City of Surrey
PLANNING & DEVELOPMENT REPORT

File: 7915-0146-00

Planning Report Date: October 20, 2015

to permit the development of a single-storey multi-tenant commercial building.

SITEPLAN

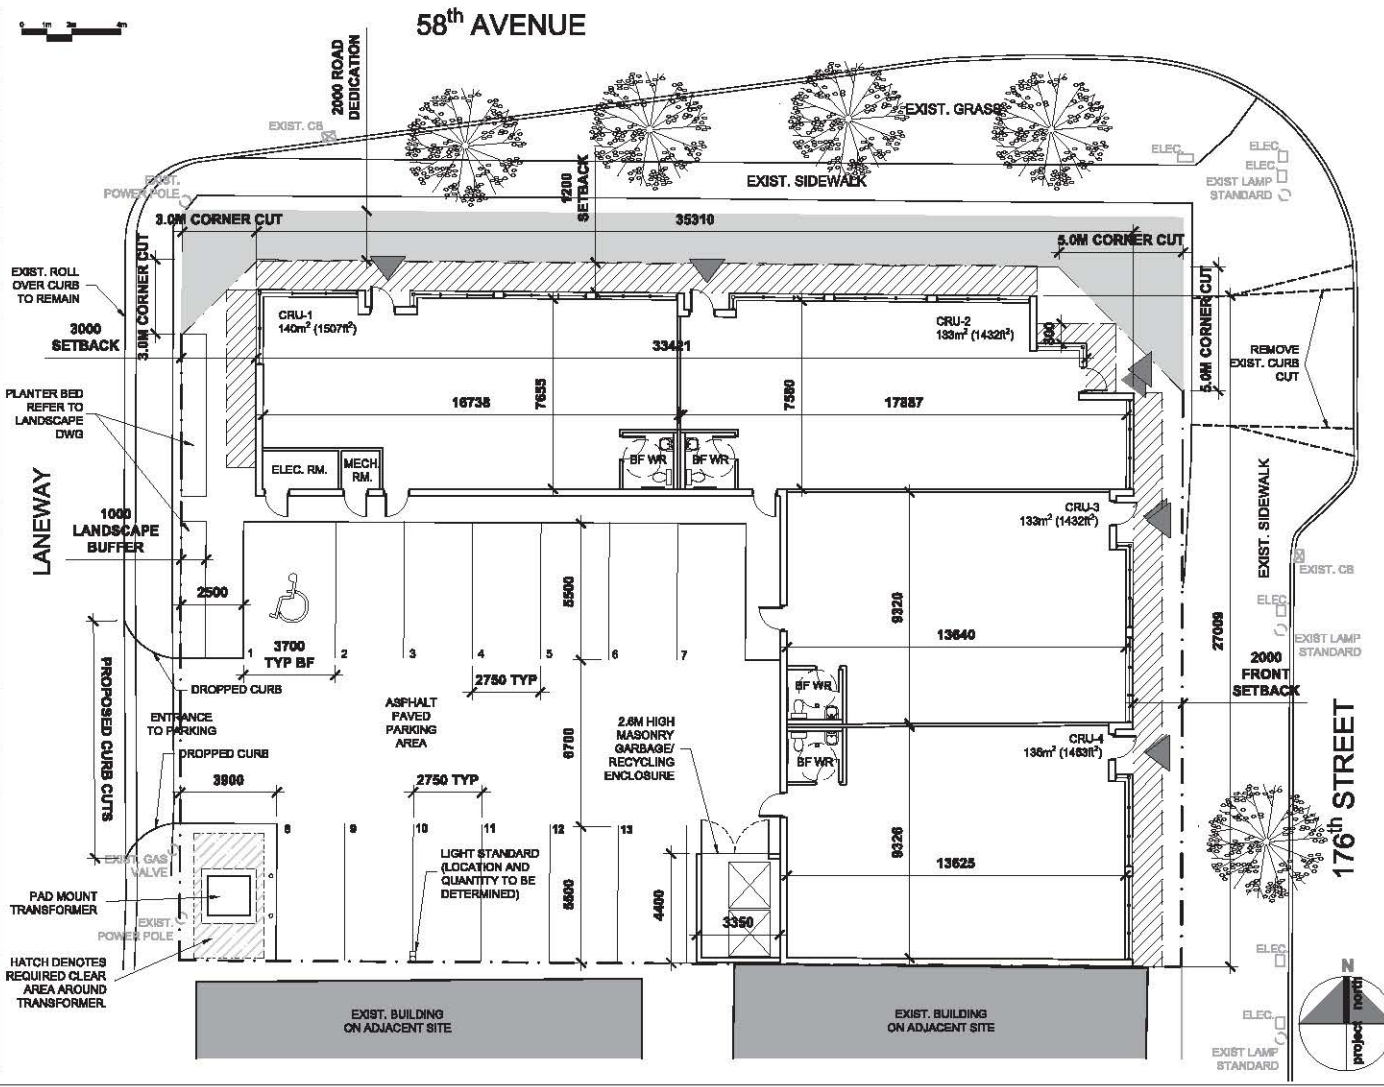
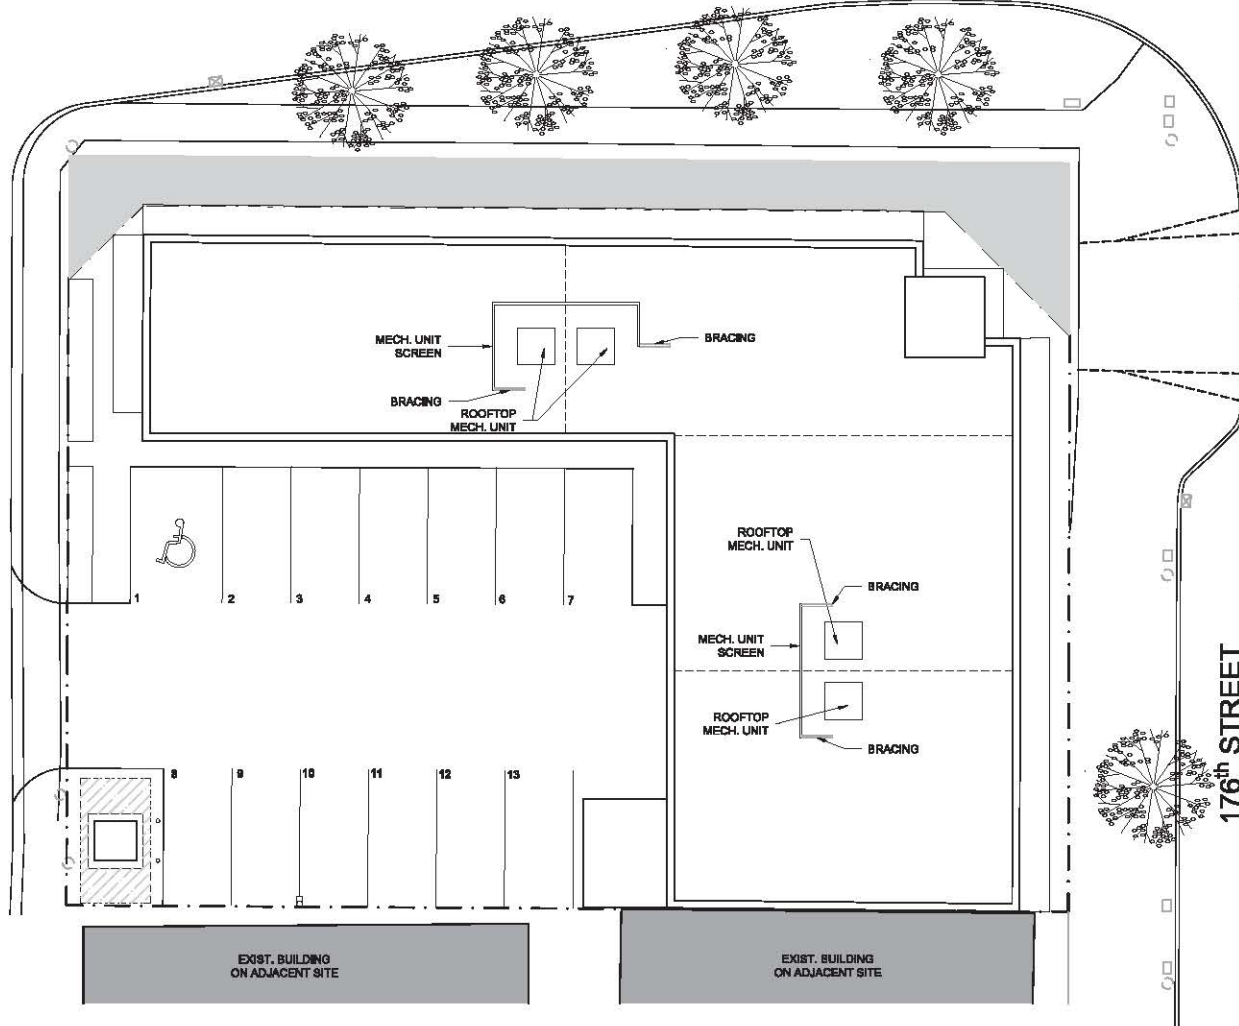
- The garbage could be relocated to open up views into the parking but keeping landscape screening of the cars.

- Recommend re-location of the garbage. The whole lot should be visible before a person walks into it. Also vulnerable to graffiti.

(Through discussion with staff it has been agreed that the garbage enclosure will be located adjacent to the south side of the building. See site plan. The relocation will open up the view from the laneway into the parking lot. The planting strip along the parking provides screening of the cars.)

(Through discussion with staff it has been agreed that the garbage enclosure will be located adjacent to the south side of the building. See site plan. The relocation will open up the view from the laneway into the parking lot. The planting strip along the parking provides screening of the cars.)

East Elevation - 1:100

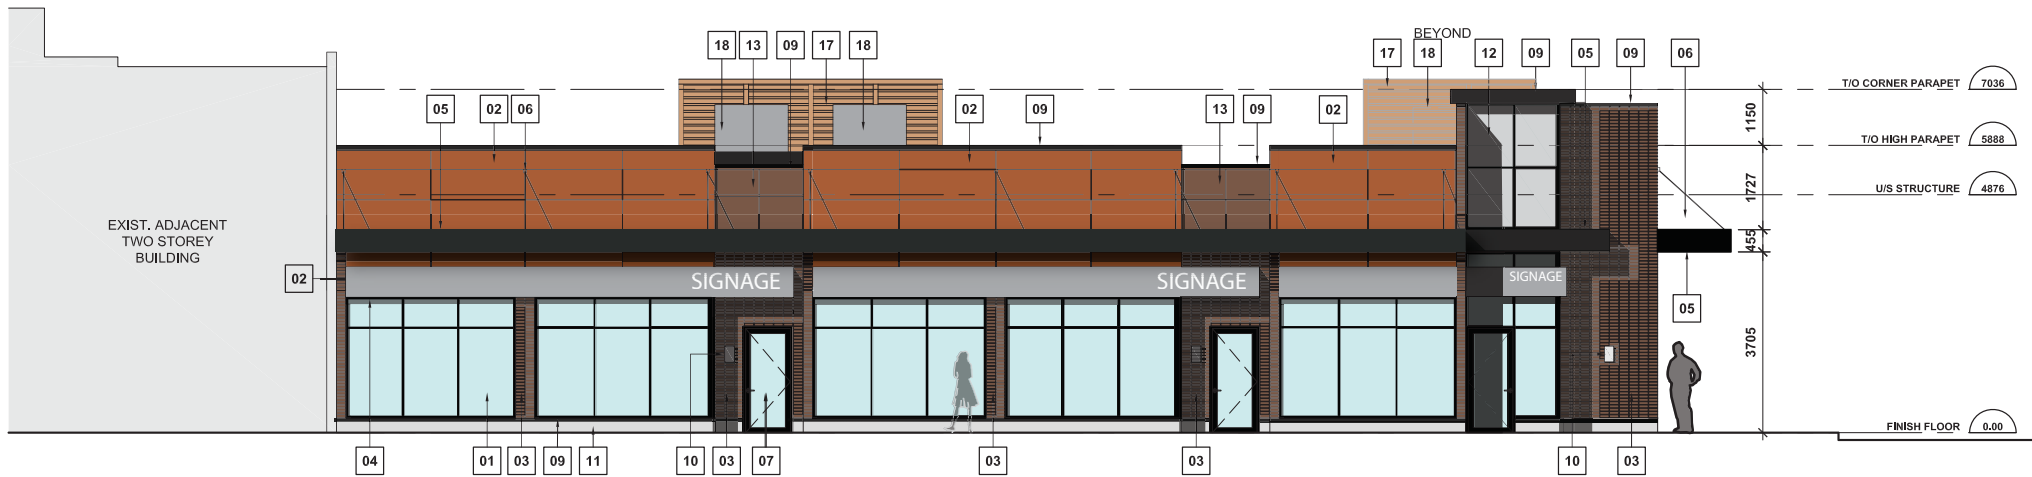
- Consider deeper canopy to provide greater rain protection.

- Encourage the weather protection canopy to out an extra foot to enable two people to walk past each other.

- Retain consistent background on signage.

- Consider hardi panel system, nice crisp reveal, more refined, chunky trim.

(Weather protection canopy has been changed from 1.0m deep to 1.2m deep.)

(Weather protection canopy has been changed from 1.0m deep to 1.2m deep.)

(Proposed signage will be non-internally illuminated, have consistent grey-coloured background with raised individual lettering. See building elevations.)

(Cement fiber reinforced panels (HardiBoard) is proposed with inset reveal between each panel joint. See building elevations.)

West Elevation - 1:100

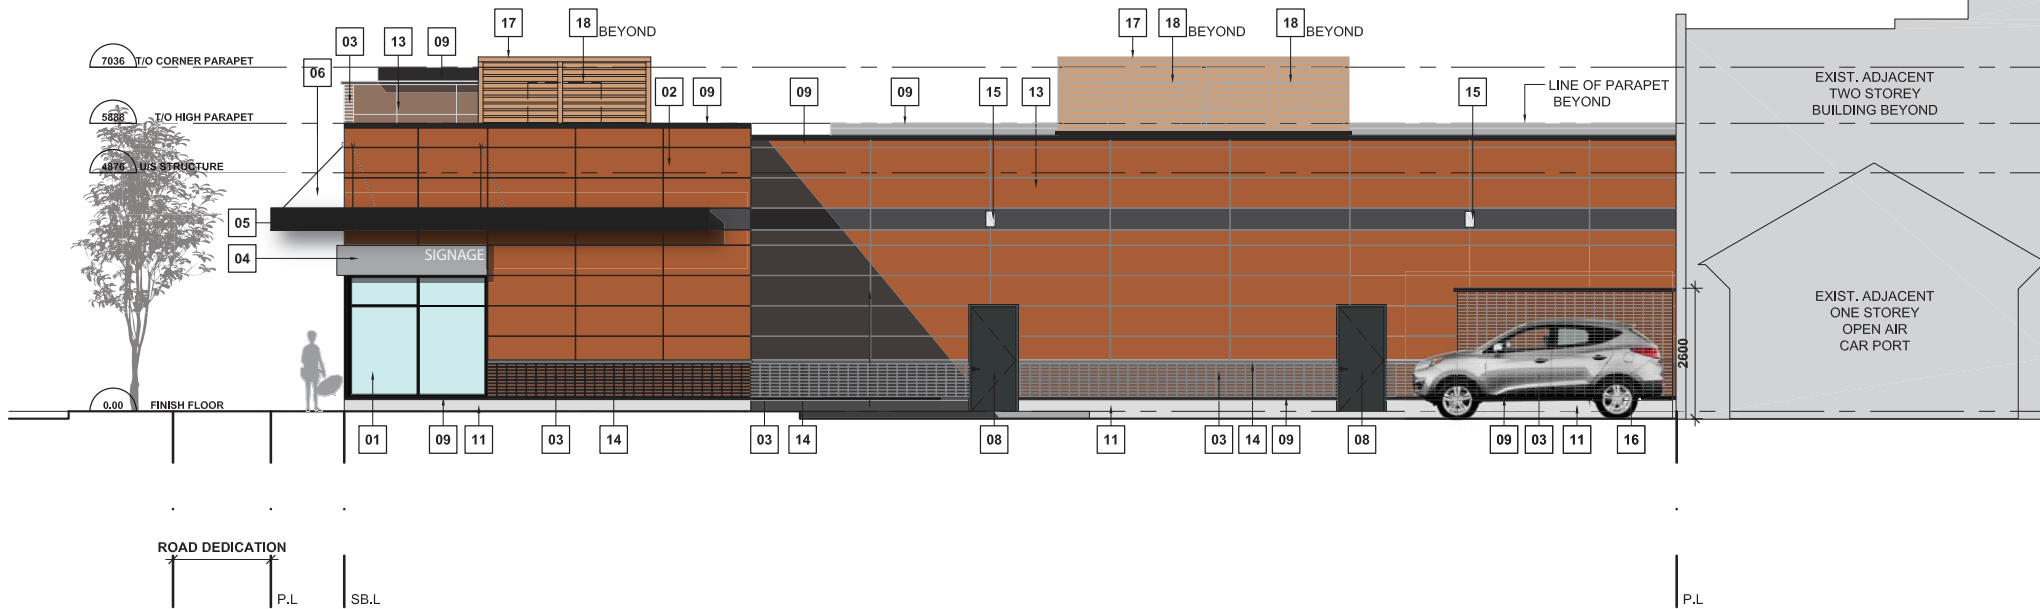
- Consider trellis with vines on parking lot wall to break large expanses of Hardie panel.

(Due to the relocation of the garbage enclosure, there is now insufficient room to introduce planting and associated trellis on the west elevation of the building at the east end of the parking lot. In lieu of this, we have created more interest to the façade by introducing an accent colour band in the cement fiber reinforced panels. See building elevations.)

SITEPLAN
PROPOSED RETAIL DEVELOPMENT - RE-SUBMISSION TO ADP
 5791 - 176 STREET, SURREY, BC

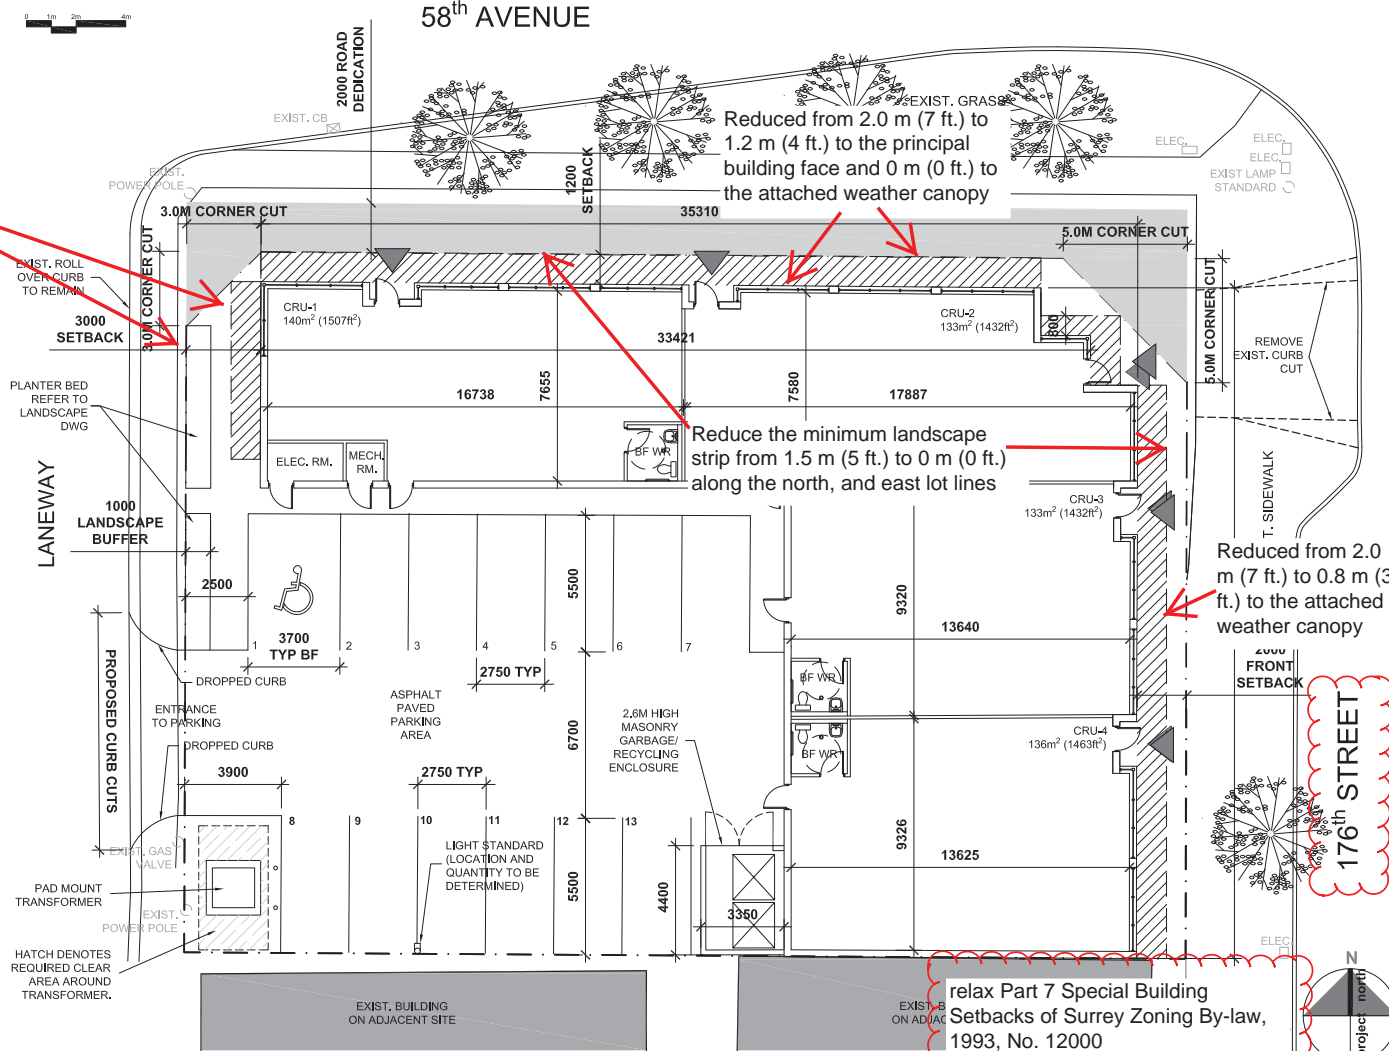
Reduced from 7.5 m (25 ft.) to 3.0 m (10 ft.) to the principal building face and 1.8 m (6 ft.) to the attached weather canopy

Reduced from 2.0 m (7 ft.) to 1.2 m (4 ft.) to the principal building face and 0 m (0 ft.) to the attached weather canopy

Reduce the minimum landscape strip from 1.5 m (5 ft.) to 0 m (0 ft.) along the north, and east lot lines

Reduced from 2.0 m (7 ft.) to 0.8 m (3 ft.) to the attached weather canopy

relax Part 7 Special Building Setbacks of Surrey Zoning By-law, 1993, No. 12000 to reduce the sum of one-half of the ultimate highway allowance for 176 Street and the front yard setback from 14 metres (46ft.) to 12 metres (39 ft.) to the principal building face and 10.8 metres (35 ft.) to the attached weather protection canopy.
